AMENDMENTS TO THE DRAWINGS

REMARKS

Fig.1

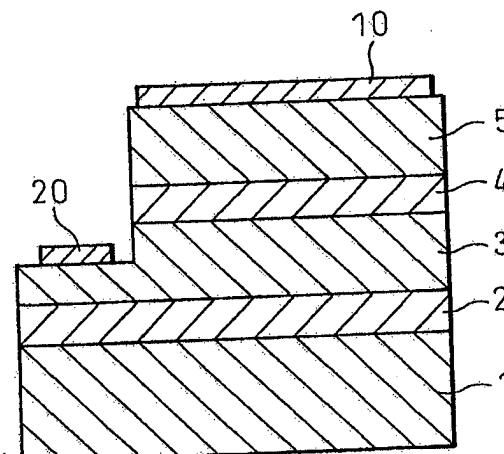
In response to the drawing objection, a replacement sheet is submitted herewith so as to label Figure 1 as --Prior Art--, and to change the drawing sheet pagination from "1/1" to "1/2". In addition, a new drawing sheet (Figure 3) is submitted herewith to show the feature of "a light-emitting diode comprising a flip-chip-type gallium nitride compound semiconductor light-emitting device".

In response to the drawing objection, a replacement sheet is submitted herewith so as to label Figure 1 as --Prior Art--.

~~1~~ 1/2
